2020 Stevens Creek Quarry Annual SMARA Inspection

County File PLN07-1253-2020-Annual Report State Mine ID #91-43-0007

Inspection Date: September 14, 2020

Photo 15: Panorama of buttress fill below retaining wall on northwest high wall.

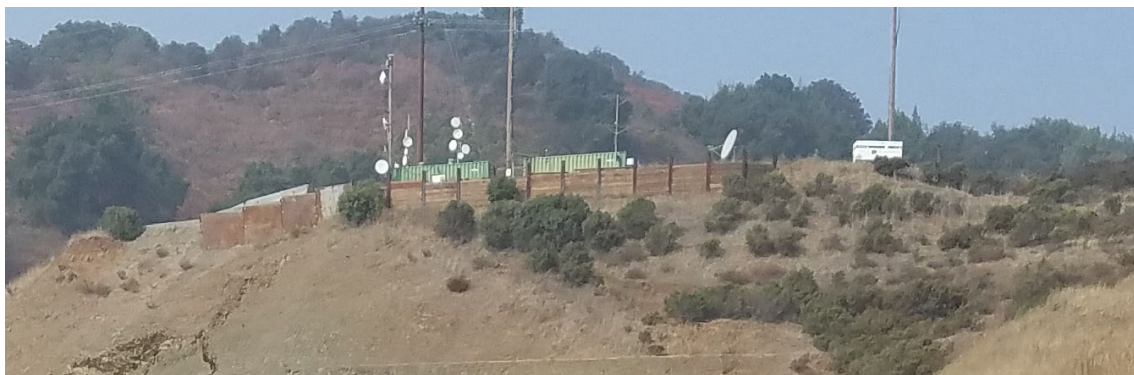
Another slope failure has disrupted the cut slope on the northwest side of the quarry pit. The headscarp of that failure has affected the southern end of the retaining wall built to protect the radio shack at the top of the slope. [See **Photos 13 and 15** below.]
